**Addendum to the EIAR - Downward Tunnel Realignment:  
St Stephen's Green Station to Charlemont Station**

06/03/24

The vertical alignment has been reviewed to provide 5m deeper clearance below the ground anchors at the Irish Life building (Ch19+000). The horizontal alignment between St Stephen's Green and Charlemont Station (Ch18+540 and Ch19+300) is unchanged from the Proposed RO Works.

**Figure 1 Horizontal Alignment**

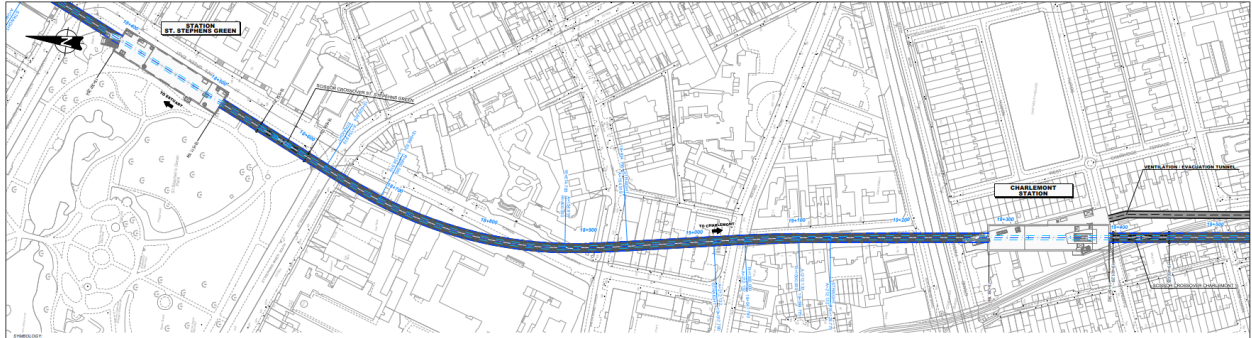
In order to ensure that there is no direct impact on these properties and to minimise any potential indirect impacts it is proposed to lower the tunnel a further 5m deeper along the tunnel at Ch18+940 (Below the junction of Hatch Street and Earlsfort Terrace). This will mean that the tunnel will be at a maximum of 5m deeper at the location identified above with the differential in depth decreasing as the alignment ties back into St Stephen's Green Station to the north and Charlemont Station to the south.
